From: Phil Heitzenroeder
Sent: Tuesday, February 10, 2004 8:49 AM
To: Jim Chrzanowski (jchrzanowski@pppl.gov)
Subject: Info on cable properties from Len

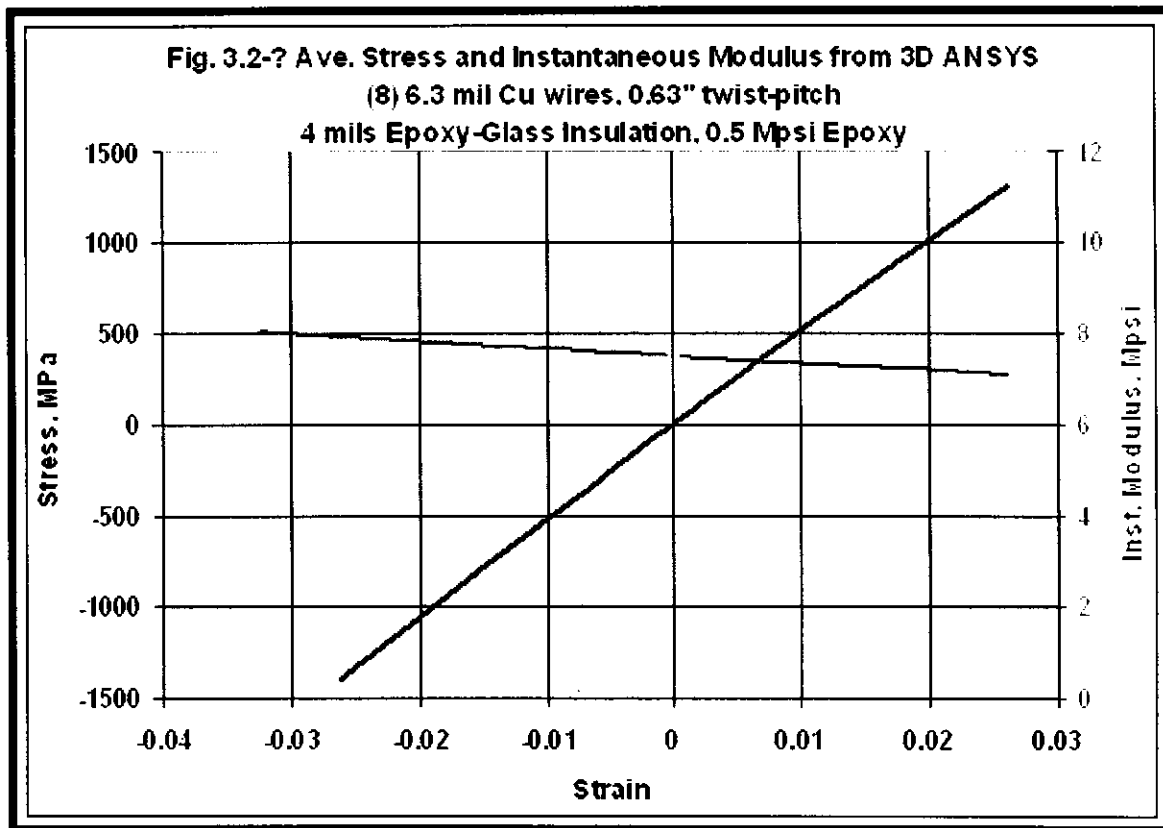
I made two ANSYS runs of my 8-strand cable model to answer this question; one in tension, and the other in compression. I also applied the rule of mixtures. Again, the model is pretty consistent with the hand calculation, and higher than we see in the test data. The model indicates a modulus of 7.5 Mpsi, while the hand calculation results in 7.7 Mpsi. The plot below shows the stress-strain curve (in black) and the local derivative representing the modulus (in blue). Recall that the 10 GPa epoxy results in a cable modulus of about 8 Mpsi.

This indicates that the epoxy modulus has a small impact on the composite cable modulus. It, of course, has a huge impact on the mechanical performance of the cable... since it holds everything together and does not allow any gross motion of the strands. But, the modulus is only a small part of the composite, and so any change in the modulus (even this reduction by a factor of three) has a relatively small impact on the overall average.

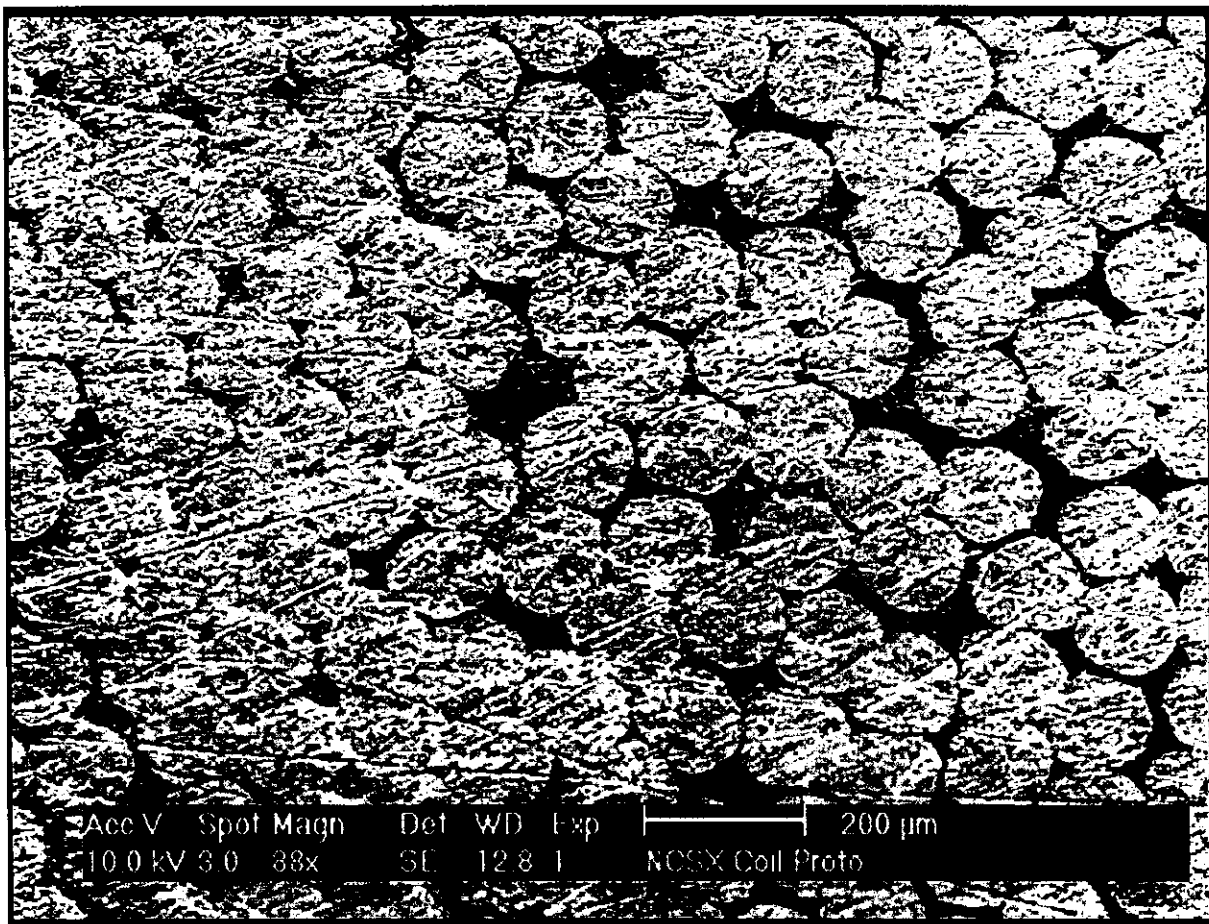
I also asked for and received some micrographs of the cable cross-section from Brad Nelson. I was curious about the strand-to-strand spacing and thoroughness of epoxy impregnation. Below are two of the micrographs Brad sent to me. The most interesting thing to notice is that a significant number of the strands are pressed into contact with their neighbors. These contact regions are easily seen in the 50 μm close-up image.

It strikes me that the strands are neither metallurgically nor epoxy-bonded at these contact surfaces. Now, the cross-section will look different at another axial position, and the unbonded strand surfaces may become bonded some distance away from the strand-to-strand contact region. But, this sets up a situation in which the impregnated cable is not a monolith, but rather a complex composite with millions of unbonded contacting surfaces of various dimensions and shapes.

Clearly, this type of structure will behave softer than our idealized monolith, as these tiny contact surfaces shear and open with applied loads. I can also imagine how an axial compressive load would be softer than an axial tensile load. Compressive loads will tend to spread apart the cable cross-section, thereby opening and shearing the tiny unbonded surfaces. Tensile loads will tend to tighten the cable cross-section, thereby closing and shearing the unbonded surfaces. Both of these actions will propagate millions of "crack fronts." The shearing comes from an almost certain non-uniformity in the load paths. The behavior of these micro-contact surfaces must be seen as a

softening effect relative to the behavior of an idealized monolithic composite.

My feeling is that microcracks are responsible for the softer-than-expected composite modulus. But I have not yet thought of a simple model to help demonstrate this theory.
